APPLICATION NO.	FILING DATE	FIRST NAMED INVENTOR	ATTORNEY DOCKET NO.	CONFIRMATION NO.
09/892,210	06/26/2001	John David Schmidt	2316.1459US01	9354

Office Action Summary

DETAILED ACTION

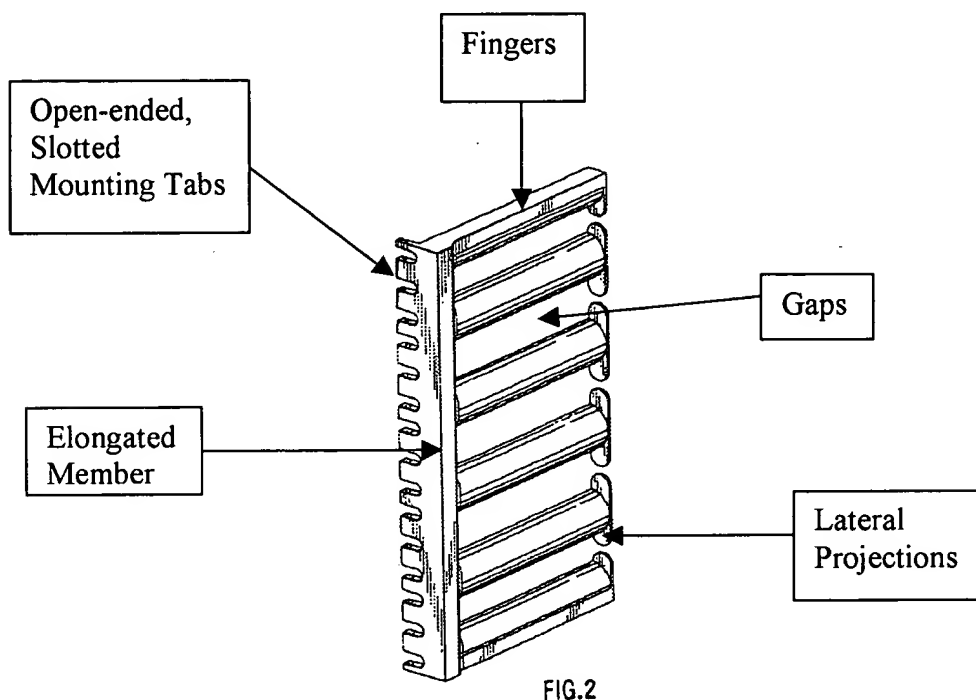
Witty discloses a cable management bracket 501 comprising a L-shaped elongated member 502, a plurality of slotted mounting tabs 505 and a plurality of fingers 508 spaced apart along a length of the elongated member 502 in the vertical direction. The fingers 508 define gaps 510 between the fingers 508 to receive telecommunications cables. The fingers 508 include bend radius limiter portions 528, which have a curved surface. Witty discloses that the bracket 501 is mounted on a support member 540. Furthermore, Witty teaches that the slotted mounting tabs 505 allows the bracket 501 to be mounted to a rack with the same fasteners used to mount a corresponding piece of telecommunications equipment to the rack by loosening the fasteners then sliding the bracket 501 into place with the fasteners received within a slot 509 of the mounting tabs 505 and re-tightening the fasteners to hold the bracket 501 in place (see paragraph [0065]). However, Witty does not disclose a cabinet frame enclosing the support members 540 and the bracket 501. Therefore, Witty does not show the support members 540 being recessed from a front of the cabinet frame or the fingers 508 being spaced from side walls of the cabinet frame to create a vertical cable pathway between the fingers and one of the side walls. Claim 8, line 1 recites a cabinet to be **an existing** telecommunications cabinet.
